# Service Bulletin

**Document:** SB197

**Title:** Replacing a Soft-Start

**Applies To:** Replacing *Square-D™* or *GE QS2 series* With an *ABB™* Soft-Start

**Figure 2: Control Power Wiring Diagram**

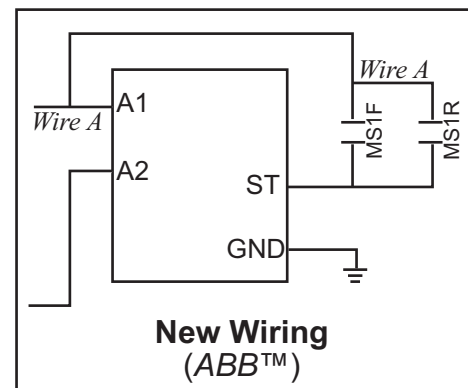
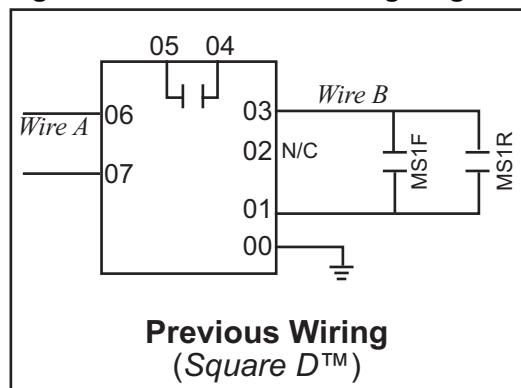
8. Screw the replacement soft-start in place.
9. Connect the wiring as indicated in Table 2 and Table 3 on page 6.
10. Adjust the potentiometer switches as they are shown in Figure 3 on page 7.

Old Terminals		CONTROL Power	
GE #	Square D #	Wire # <i>(write in)</i>	New Terminal #
A1	6		A1
A2	7		A2
2	3		See Figure 2
57	1		ST
	0		GND
